Date: August 31, 2011
 By: J. Santacruz

U.S. ROUTE 2

U.S. ROUTE 2 PROFILE	PROJECT NAME: RICHMOND	PLOT DATE: 8/25/2011
	PROJECT NUMBER: STP-RS 0284(III)	DRAWN BY: C.A.K.
	FILE NAME:	CHECKED BY: D.E.G.
	DESIGNED BY: B.T.H.	SHEET 15 OF 46
	DWG. NO.: PR-4

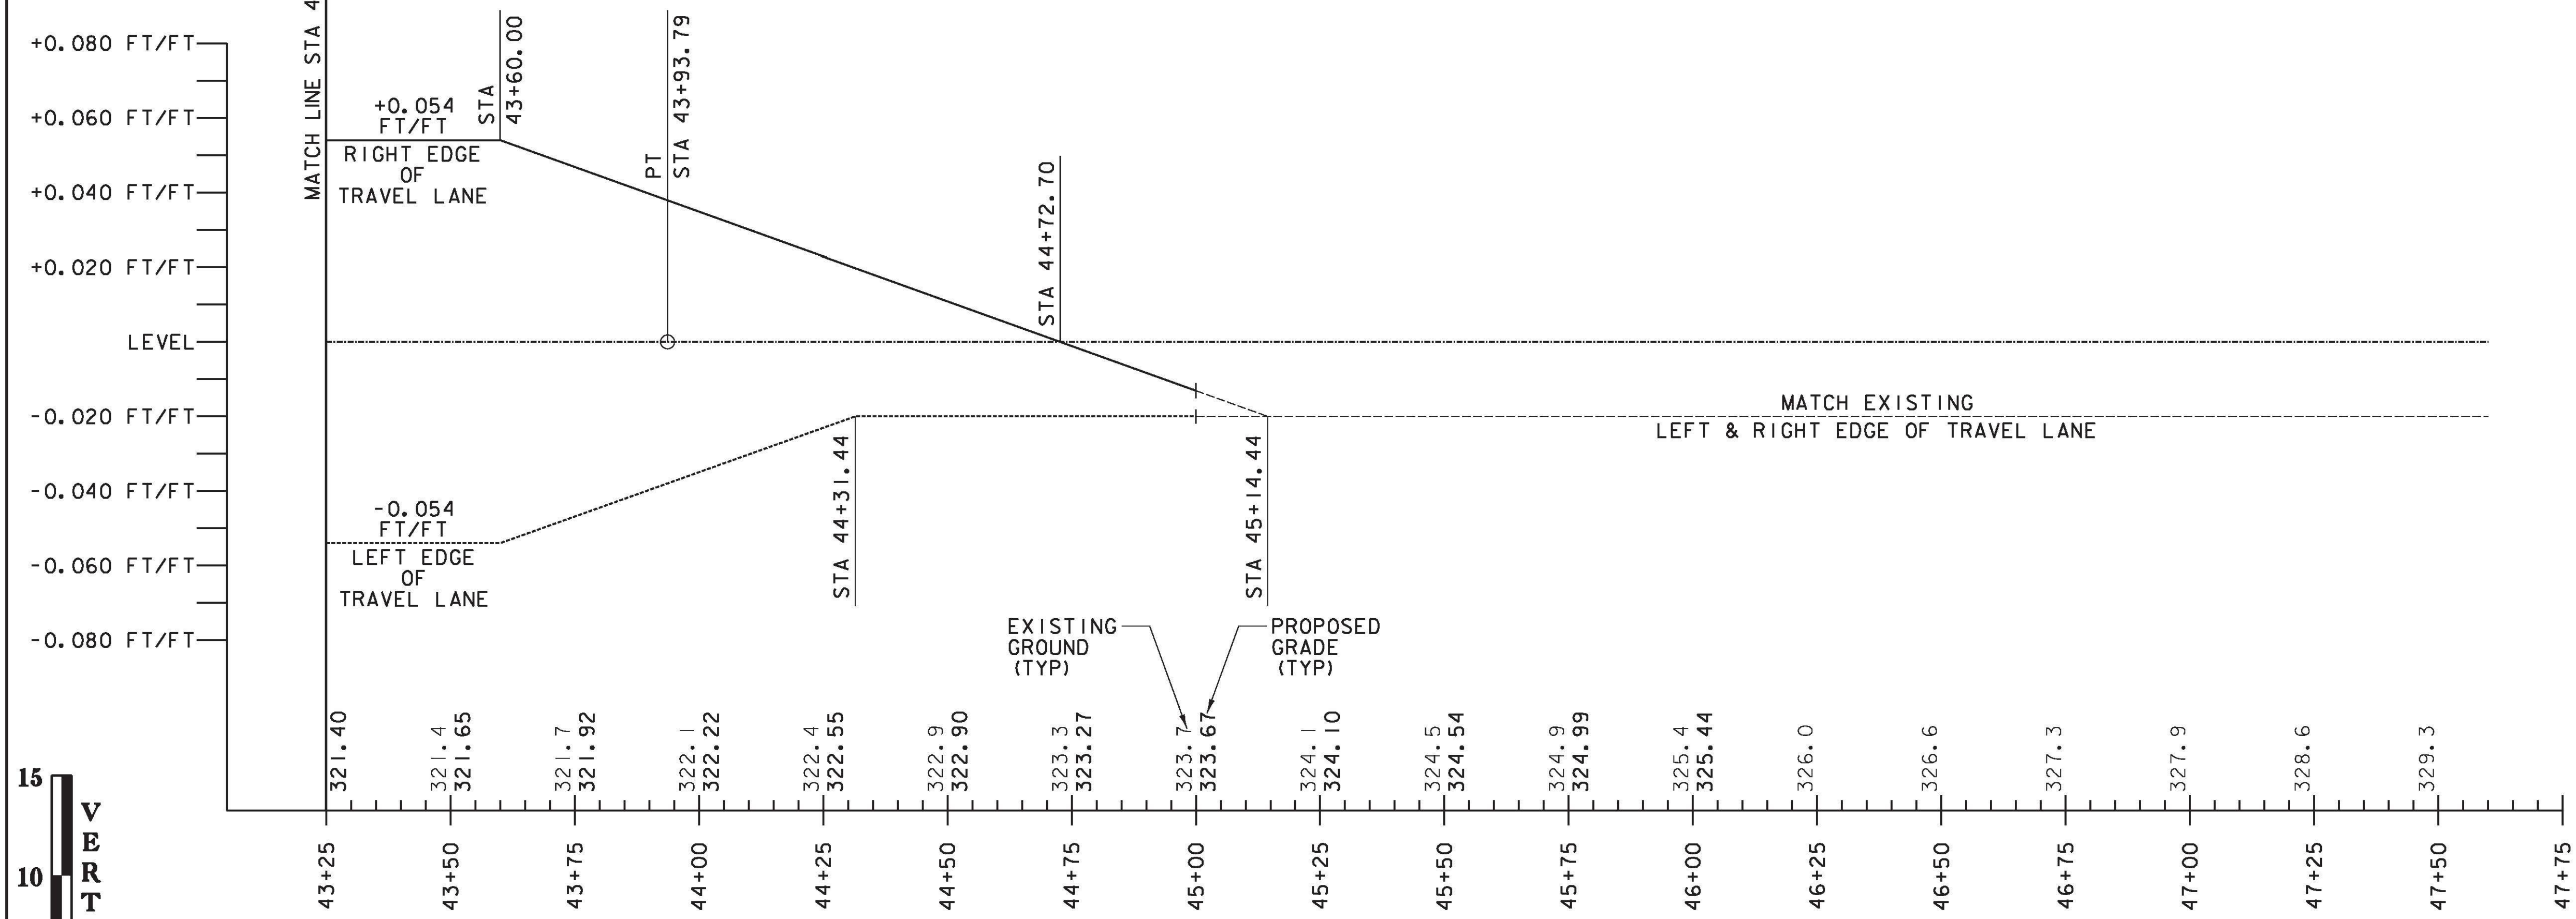
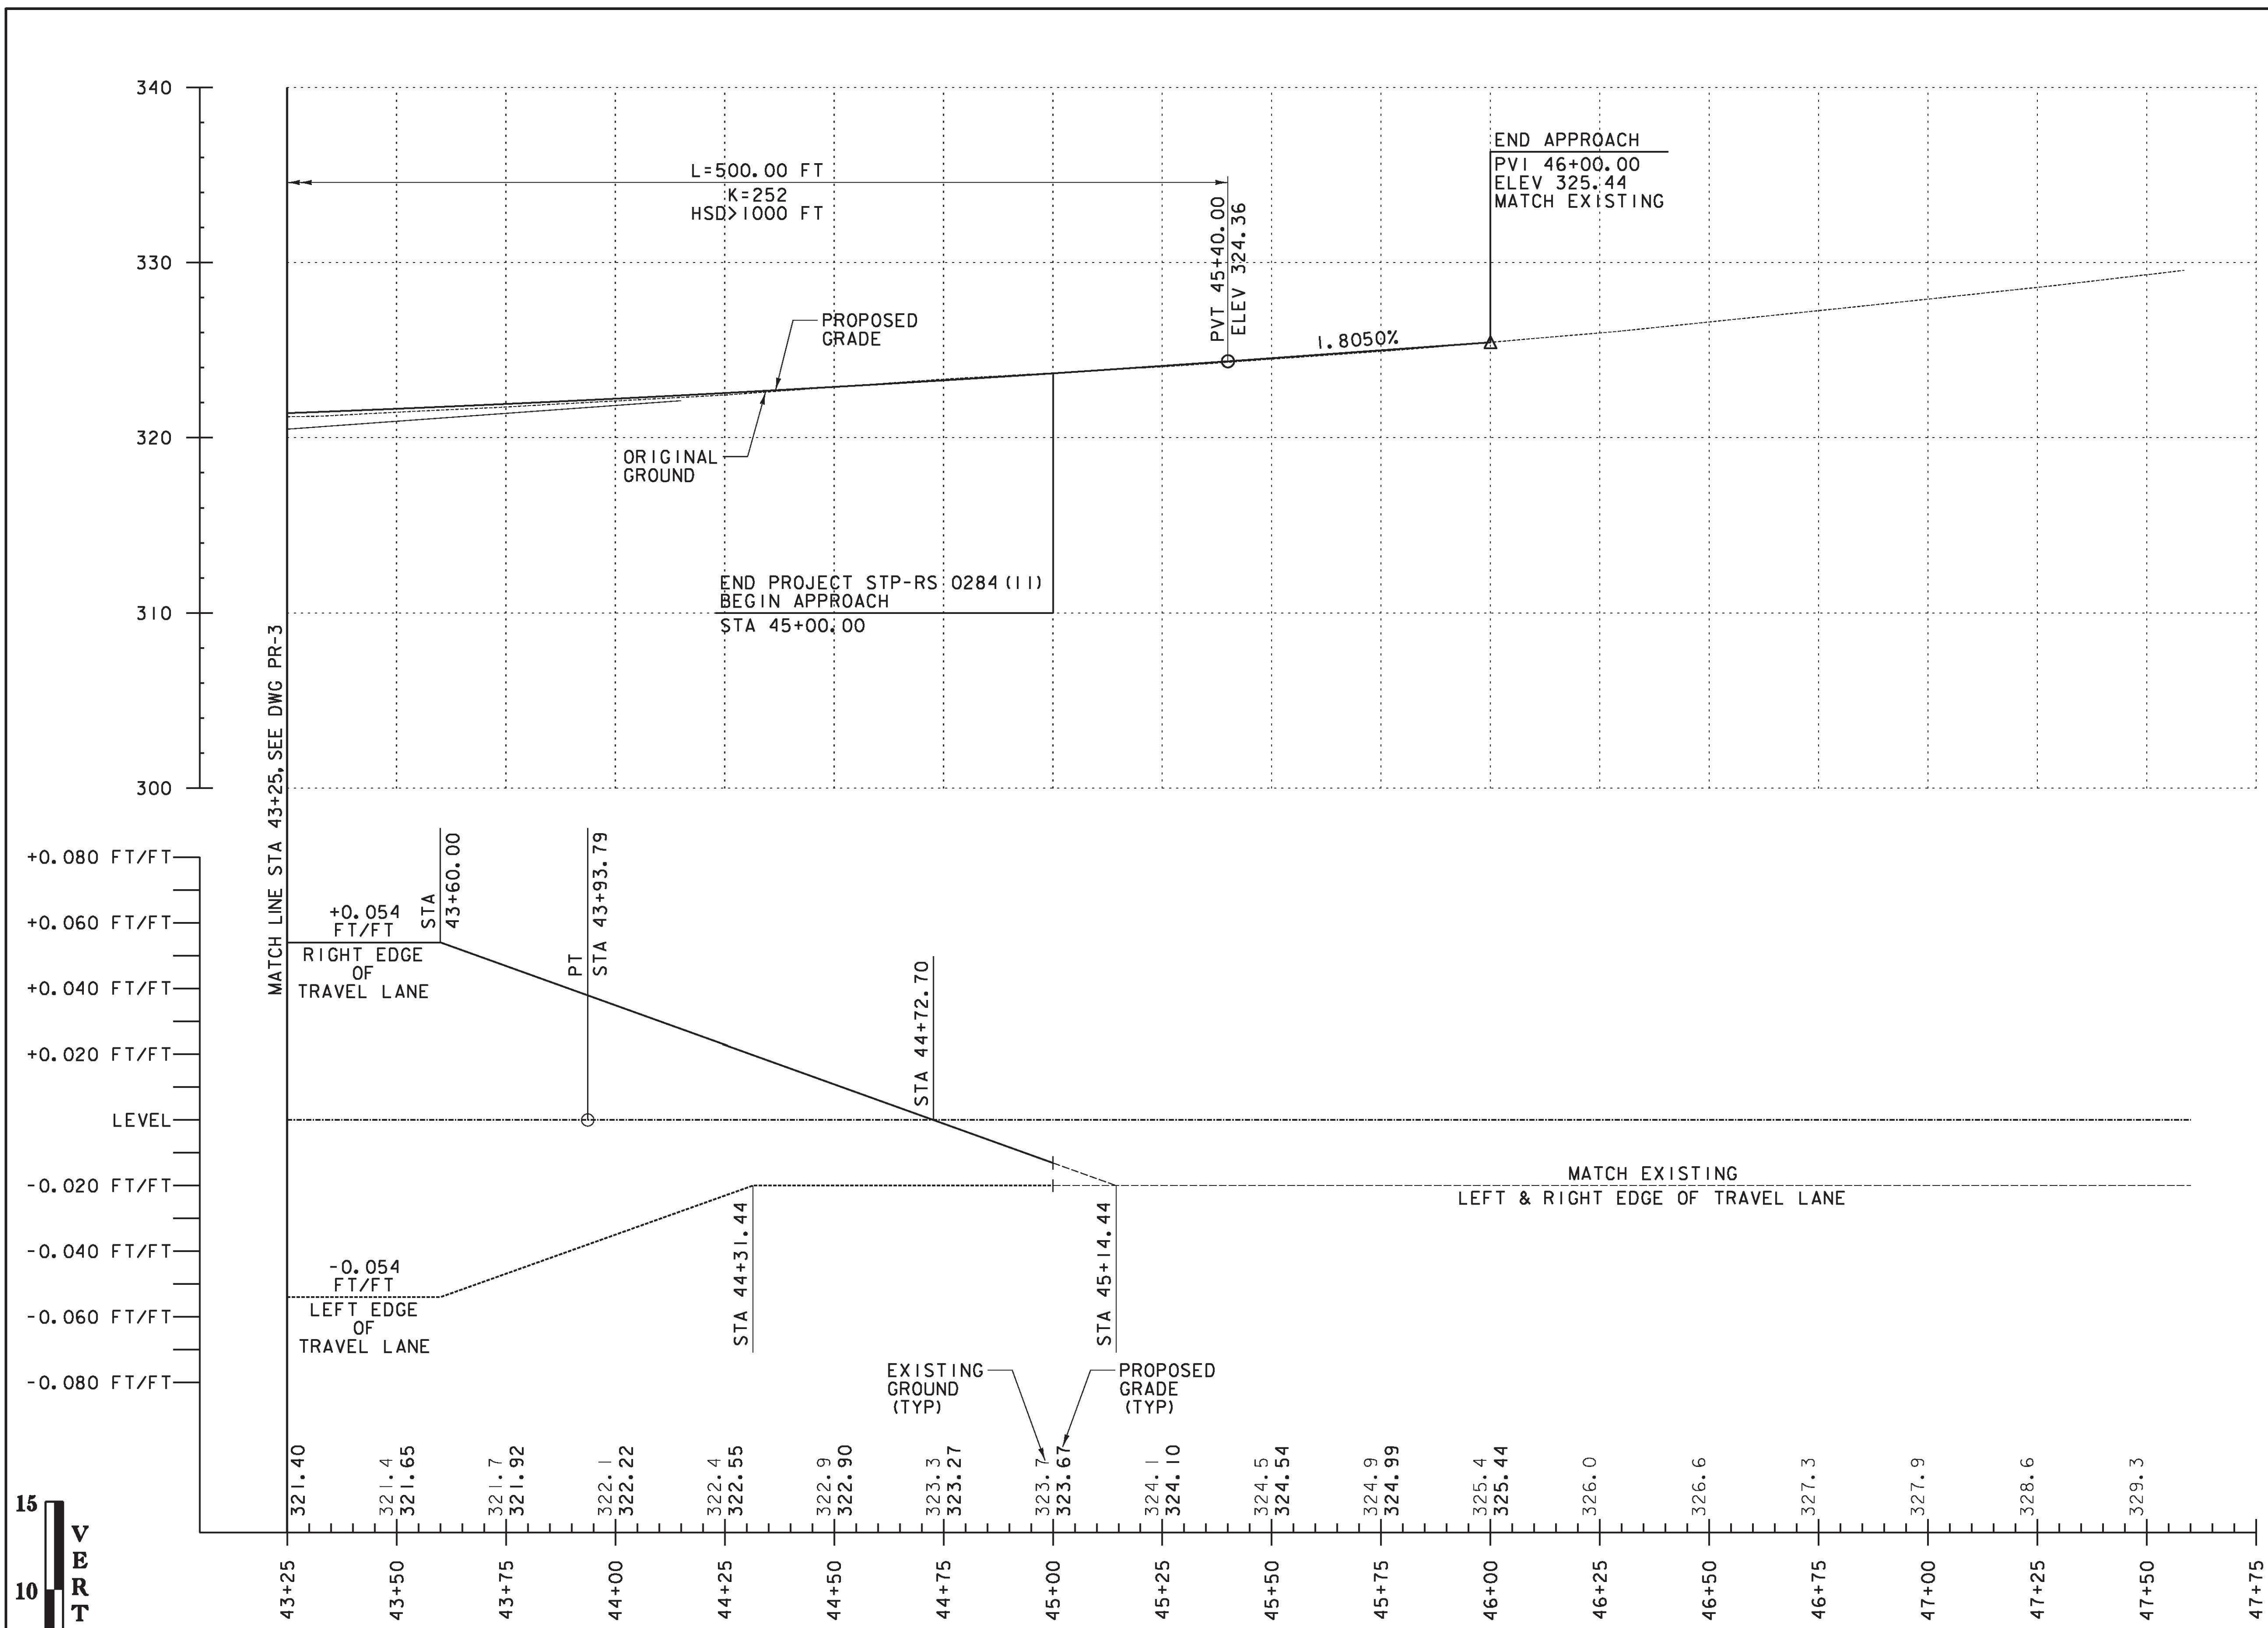
X Reviewed	Furnish As Corrected
Rejected	Revise and Resubmit
